30<sup>th</sup> May 2016

To: Fiona Morton and Tabitha Manderson  
Opus International Consultants Ltd

**Pahiatua Wastewater Treatment Plant**  
**- Proposed Discharge Location and Monitoring options**

Figure 2: Current sampling (red triangles) and potential new (yellow arrows) sampling locations for monitoring the effects of the Pahiataua WWTP discharge on the Mangatainoka River, in relation to the proposed new discharge point.

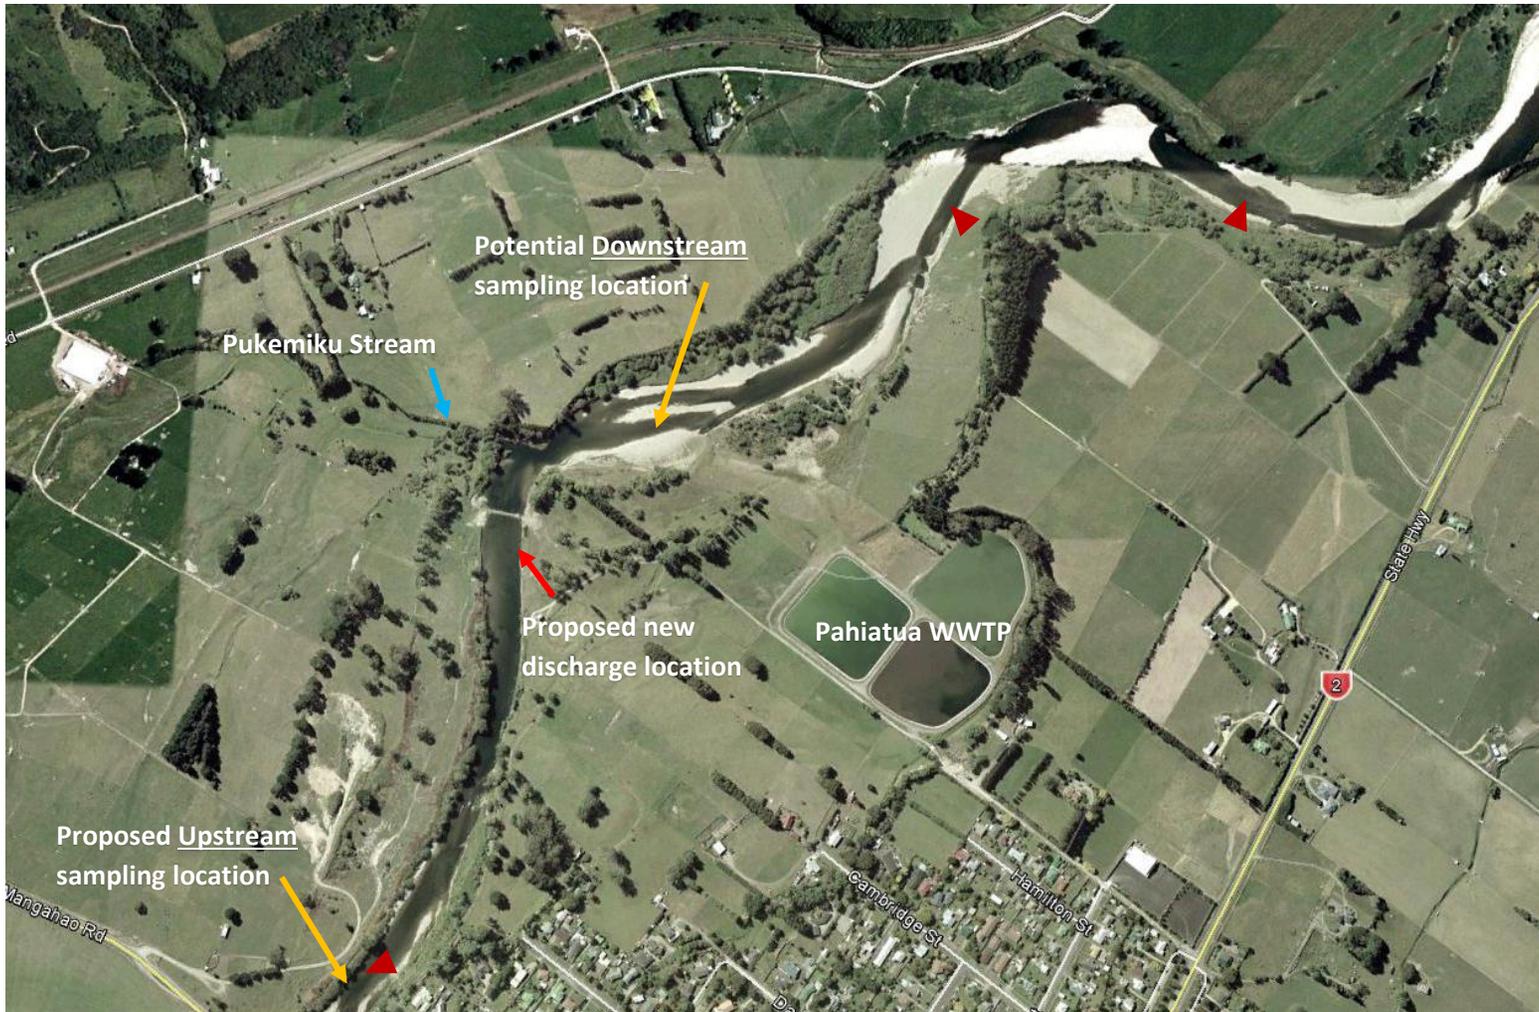
It was thought that a current HRC State of the Environment (SOE) monitoring site at the end of Tui Street, would be an appropriate upstream sampling location for both biological and physico-chemical monitoring (Figure 2).

However the downstream sampling location was not so easily determined. A level control weir (understood to have been put in place to maintain water flow into the water intake structure) spans the width of the Mangatainoka River just downstream of the new proposed discharge location. Below this is a large pool which leads into run/riffle habitat some 200 m further downstream. Mixing of the discharge with river water is likely to be reasonable by the time it reaches the riffle habitat. This run-riffle habitat would form the potentially suitable site for water quality, periphyton and macroinvertebrate sampling. However, a spring-

fed tributary (the Pukemiku Stream) flows into the Mangatainoka River on the true left bank immediately downstream of the level control weir, i.e. between the proposed discharge point and the first potential monitoring site after reasonable mixing. This stream receives stormwater from the Fonterra Pahiatua factory as well as groundwater and surface runoff (and associated contaminant loads) from the surrounding catchment. Given the intensively farmed landscape in its catchment and its source of flow (spring-fed), it is likely that the Pukemiku Stream will present relatively elevated nitrate-nitrogen concentrations.

Water quality sampling could be undertaken somewhere between the level control weir and the Pukemiku Stream confluence. However (1) mixing at that point is unknown and (2) safe access under a range of flow conditions would need to be confirmed.
